Response to DoP / UDRP / City of Ryde Council Comments In Relation To

MP10_0110 MOD3

74-76 Belmore Street, Ryde

Report prepared By **Nordon Jago** Architects

Image a7.1 Kone planning dimensions for residential lift cores

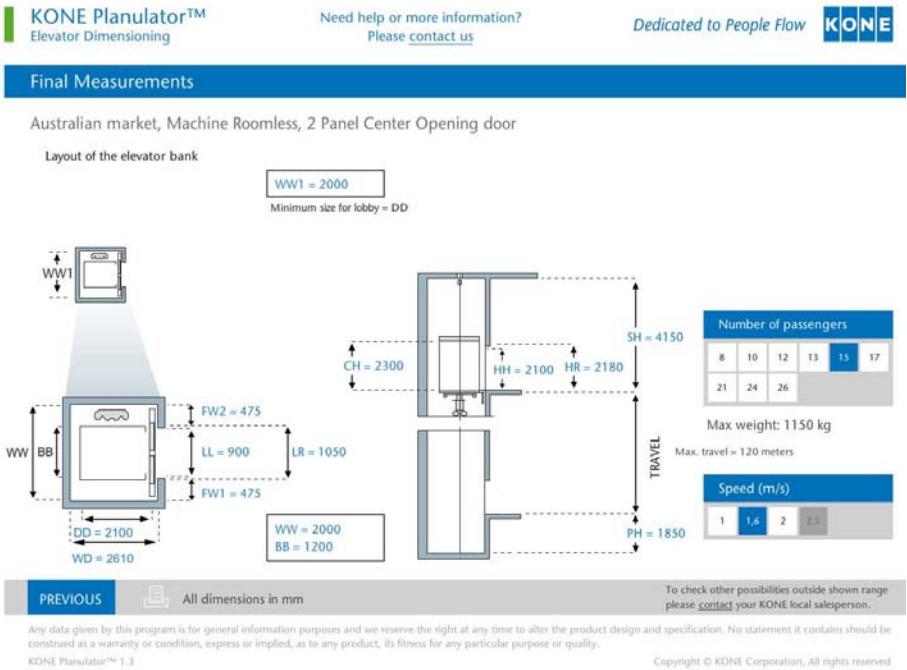
Item A.07 Lift Overruns

The increase proposed for the lift overruns is a result of having to increase the floor to floor levels of the buildings from 3000mm to 3100mm. As the envelope steps back in the upper levels the internal planning of the upper floor plates will be different from that below resulting in wet area stacks to be offset and structural beams to be increase to transfer loadings. This increase would therefore raise the seventh level

It is currently proposed to use a machine room less lifts in the development and the design has been based on the Kone N MonoSpace® lift (specification illustrated in **image a7.1**). This lift type requires an internal lift overrun height of 4150mm from the last exit level (seventh level).

Allowing for the provision of a 200mm concrete lid, and 150mm parapet hobs puts the overall height to 4500mm from the FFL of level seven. At the time of the concept approval issue a provision of 4800mm + Structure was allowed for in the envelope which was based on previous lift installations used for similar projects. Provision was allowed for in this height addition on the basis that any structural transfers in the levels below could potentially push the upper levels up by around 200 – 300mm. To cover the additional structural depth required to accommodate the stepping of the building and maintain the habitable clearances within the units, a level of tolerance was requested to the lift shaft areas.

Image a2.3 Extract of Drwg 1S.DN270[B] Illustrating separation of buildings A & E to Porter St development

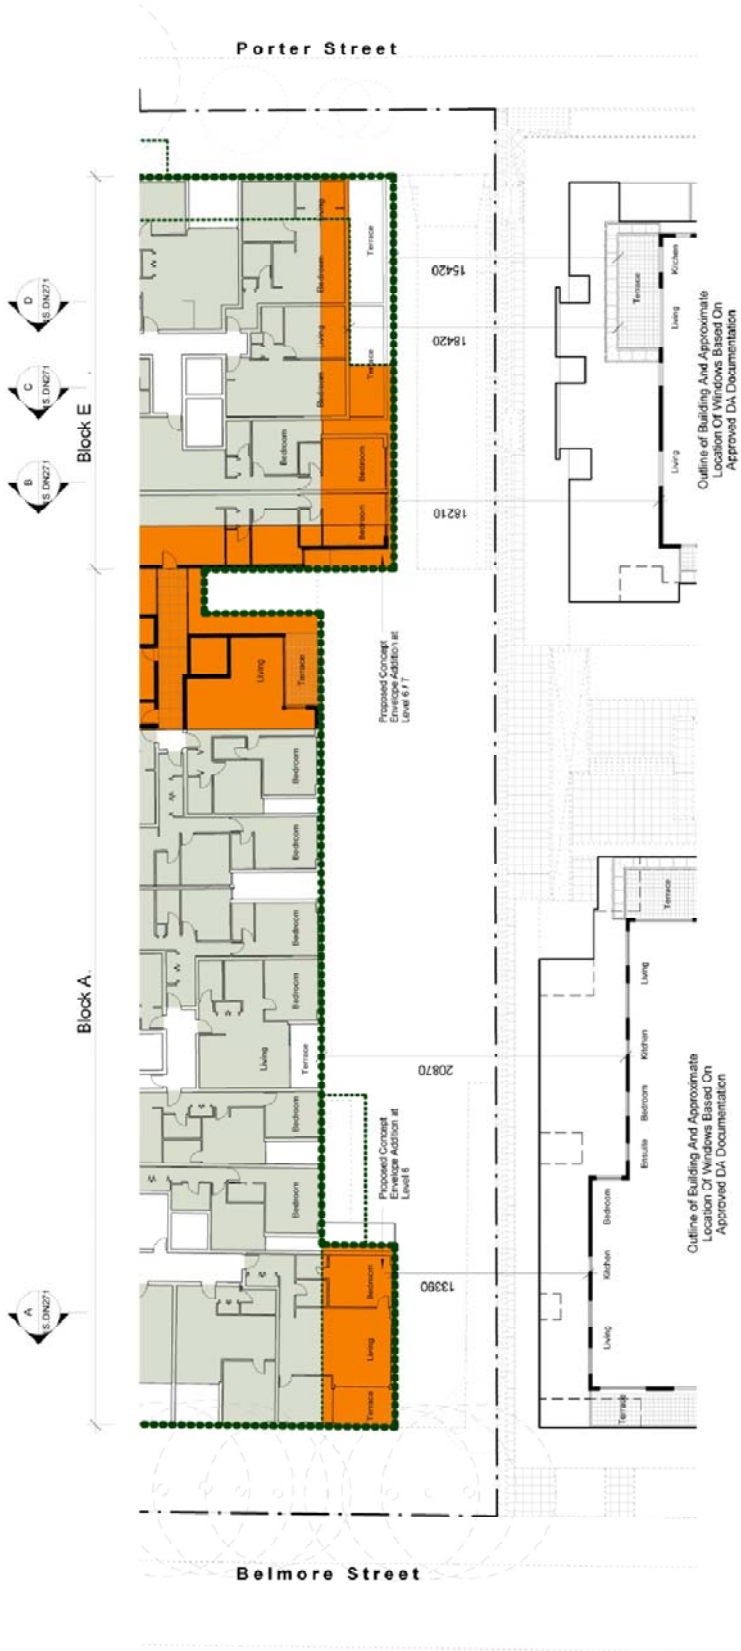
2. The UDRP made comment that the *“Changes to envelope generally reduce amenity for neighbouring lots and within the site itself”*

We have demonstrated on drawings **1S.DN270[B]** and **1S.DN055[C]** that there are no reductions in amenity to the one instance where the proposed changes to the approved envelope are adjacent to the property

Image b2.1 Extract of Building B, C and D (Plan level 4)

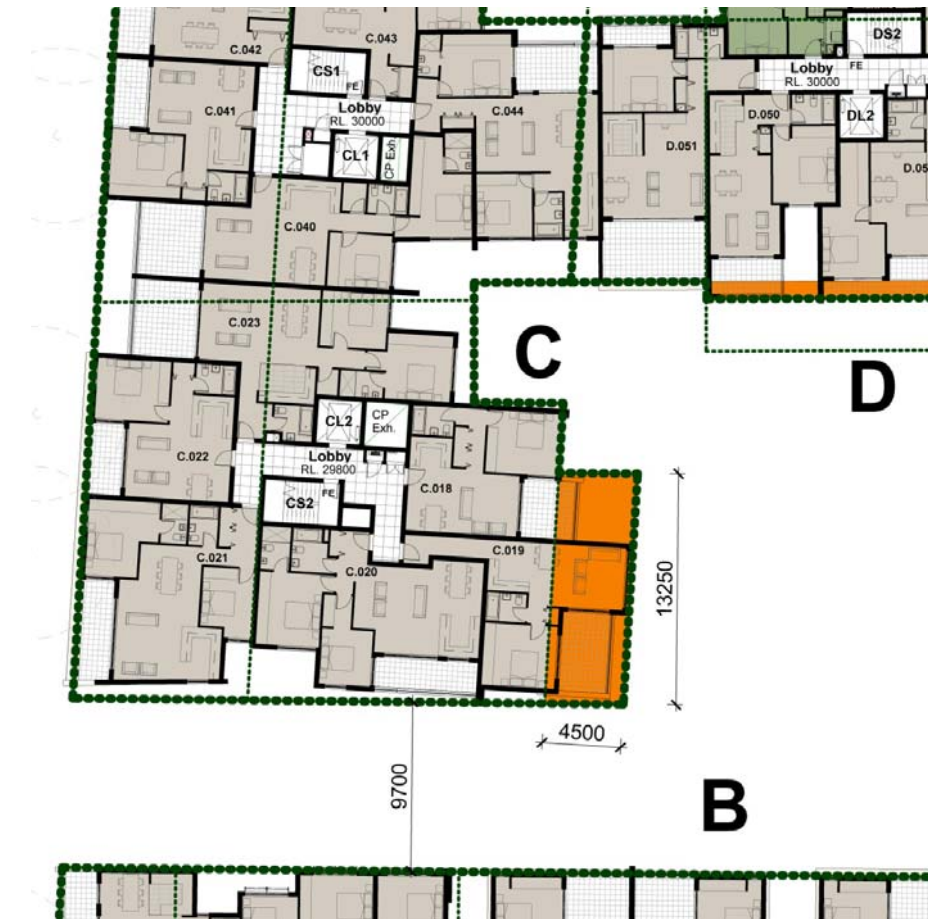
Item B.02 Extension of Building C

The proposed South West addition to the envelope of Building C is to provide an additional 4500mm in depth. The current planning does illustrate a single aspect unit design in this location (Unit C.020 as illustrated in **image b2.1**). It is noted that this unit type achieves the required 3hr solar access under SEPP 65.

The proposed separation between Buildings C and B measured at 9700mm is greater than that proposed under the current approval conditions and envelope.

To provide for the privacy of the dwellings between habitable spaces of adjacent units, privacy screens have been detailed to the bedrooms of Building B facing Building C.

The inset corner condition between Buildings C and D is a reduction to the concept envelope. It is noted that this area is predominantly fronted by bedrooms within dual orientation dwellings. Privacy between the rear units has been address through the introduction of blade walls to prevent overlooking and maintain a good level of daylight access and visual outlook from the room.

Image b4.1 Extract of Building A and E (Plan level 4)

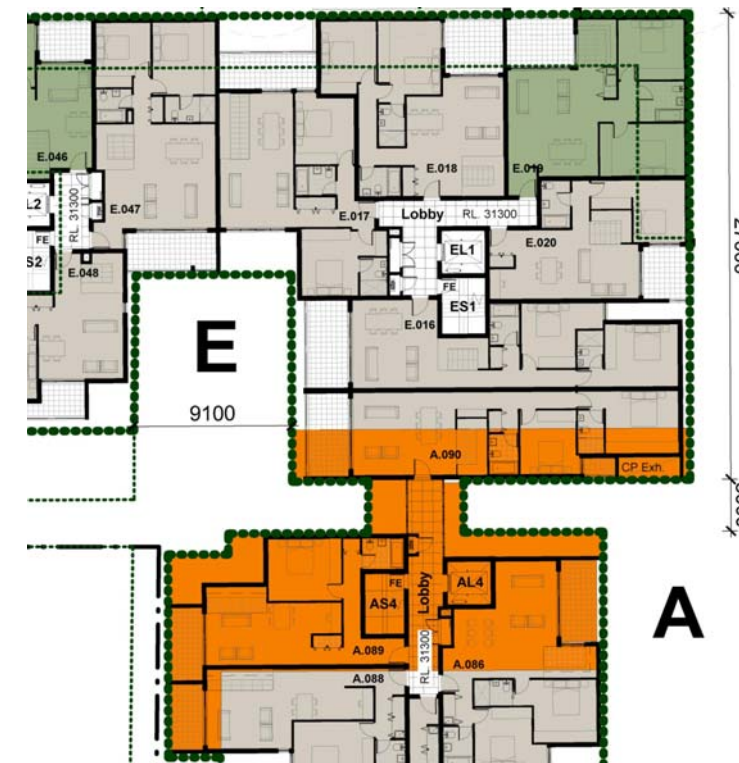
Item B.04 Separation of Building A and E

In response to the comments from the UDRP regarding the level of privacy/noise for the units in this area, it is proposed that the Unit located in the position E.047 (illustrated in **image b4.1**) at all levels be rotated so as to face the habitable balcony to the South East. This would however exclude the units from the 3hr direct solar access they currently achieve to a habitable space, and would reduce the overall percentage below the 70% for the development.

We would potentially request that an amendment to condition C2 Residential Amenity of the concept approval be considered, reducing the overall percentage required within the development down to 65% to accommodate the amendments requested by UDRP.

Image b5.1 Extract of Building A (Plan level 4)

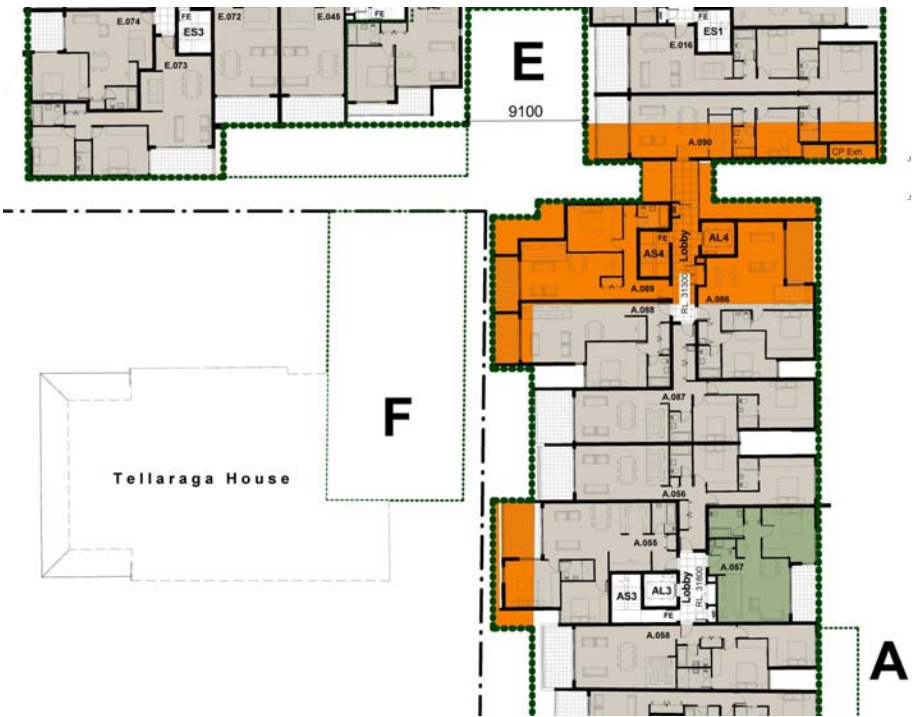
Item B.05 Encroachments at Building A into central courtyard

1. The proposed envelope additions to building A towards Tellaraga house are intended to accommodate balcony projections from the single aspect units and promote an elevational treatment with a sufficient level of articulation and fenestration, helping to break up the visual bulk of the building presenting behind Tellaraga house.

It is noted that the proposed envelope additions do not encroach or interfere with the heritage curtilage.

In response to the comments from the UDRP regarding the close proximity of the additions to building A and the prosed envelope allowed for Building F adjoining Tellaraga house, it is proposed to omit the envelope F from the concept approval.

Image b6.1 Building B envelope additions

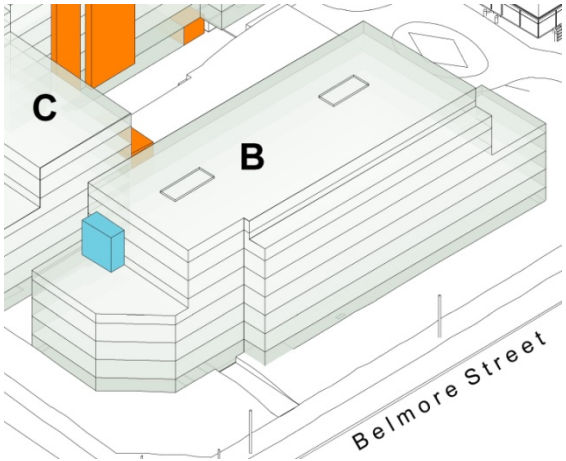
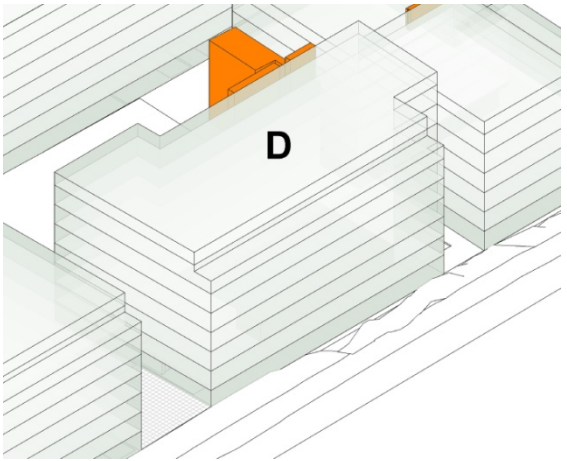
Item B.06 Encroachments into upper level setbacks at Building B and Building D

The proposed encroachments to the upper level setbacks at Building B and Building D have been withdrawn. Image b6.1 Image b6.2 describe the current proposed envelope changes.

Image c1.1 Draft Section illustrating typical arrangement of proposed floor to floor dimensions

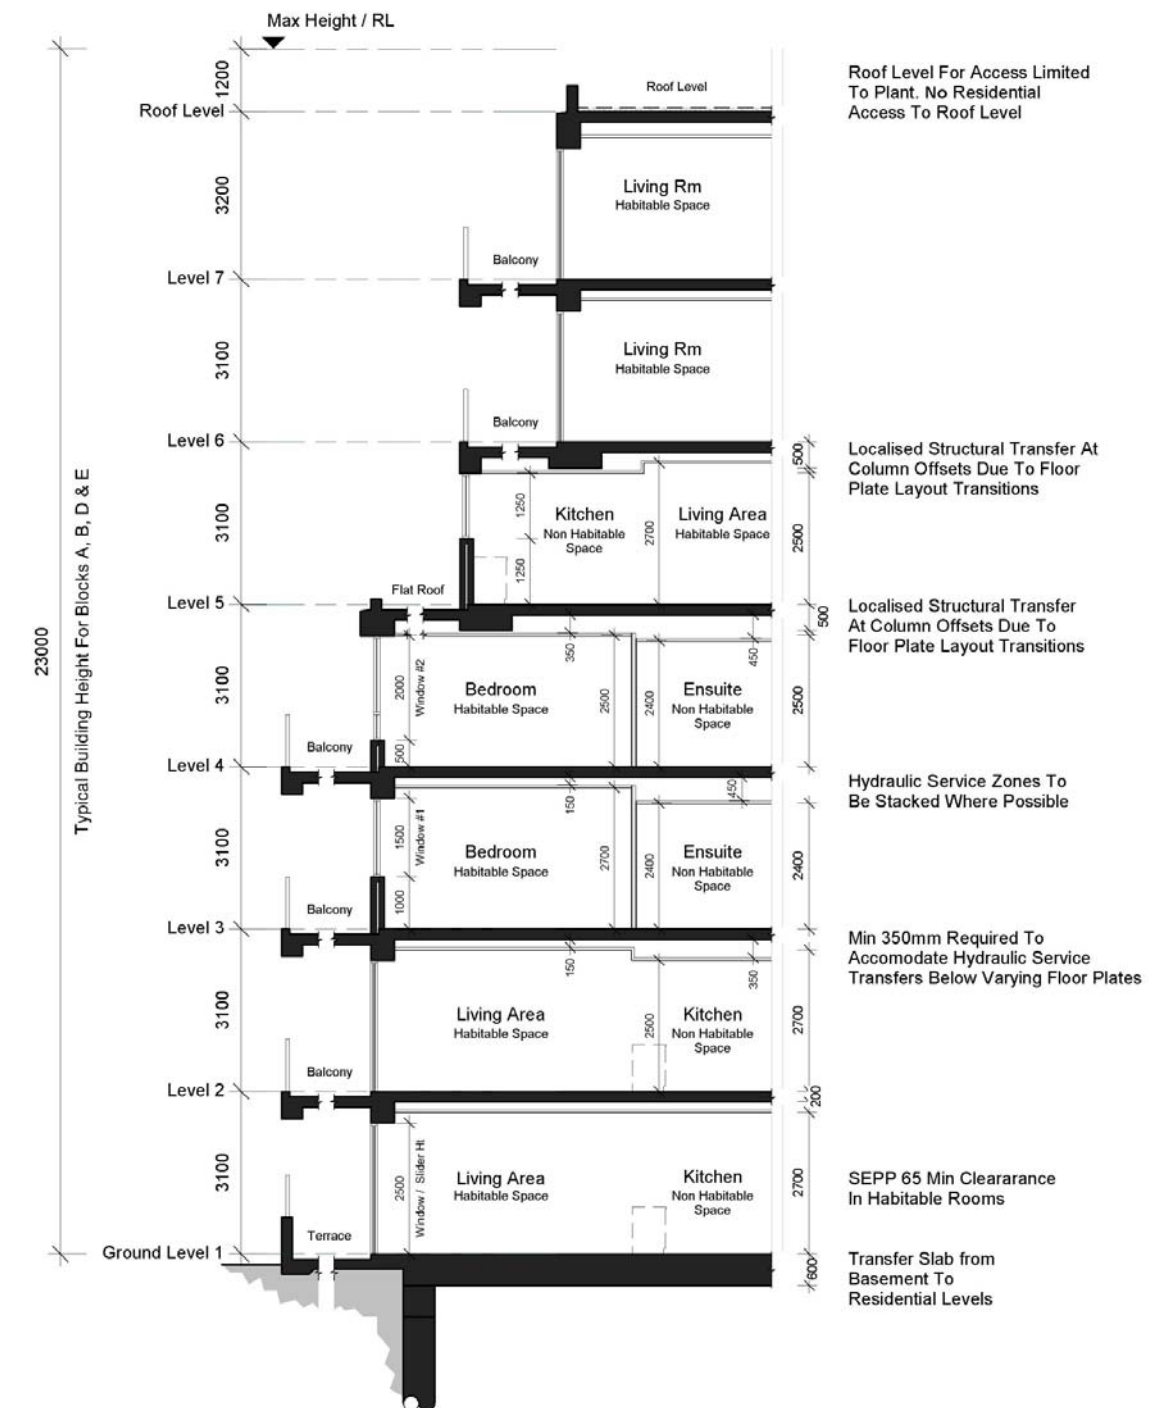
3. CoRC make comment that *"council does not support further increase to the proposed building height"*

4. Council raises concern *“that inclusion of a mezzanine level at 7th storey would add another level to the building which is considered unacceptable”*

The proposed amendments to the concept envelope do **not** increase the overall heights (maximum RL's) from those stated in the current approval condition A6. Approval has been sought for the increase in the provision for lift overruns, which are generally higher than a standard floor to floor dimension.

The current proposal does **not** indicate in any way the provision of a mezzanine level in the planning of the buildings. The proposed reduced upper seventh storey dimension excludes the possibility of establishing a habitable mezzanine level under the requirements of the BCA.

The current concept approval envelope details a floor to floor dimension of 3m per level with the upper seventh storey described as being 5m inclusive of allowance for handrails, parapets, plant rooms and clothes drying areas.

It is noted that the proposed amendment to the concept approval envelope illustrates the floor to floor provision being increased to 3.1m floor to floor with the upper seventh storey being reduced to 4.4m inclusive of handrails and parapets, (refer to **item A.07** and **image c1.1**). The proposed amendments to the floor to floor dimensions do **not** effect or increase the general overall dimension / maximum RL's noted in condition A6 of the approval.

Image c1.7 Extract of drawing 1S.DN271[B], illustrating the addition to building envelope A

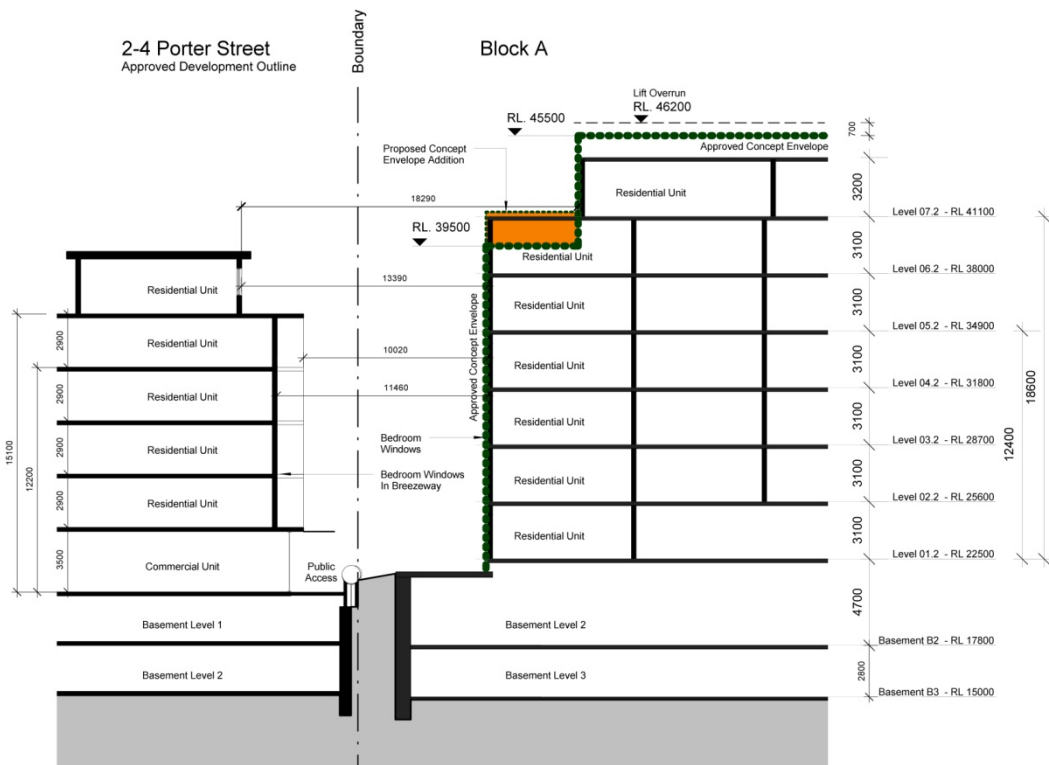
8. Council note that it *“does not support the joining up buildings A & E”.*

It has been demonstrated in the previous response **items B.04** that the effect of the additional envelope proposed between building envelopes A and E produce no reductions in amenity to the neighbouring developments, and have been proposed to improve the overall amenity of the site.

The presentation of the Western elevation will be resolved architecturally and in accordance with the approved condition C1(d) to reduce the visual bulk. It is noted that there has been a good level of articulation incorporated into the planning of the buildings, to prove a satisfactory level of modulation to the building façade helping to break down its length and bulk.
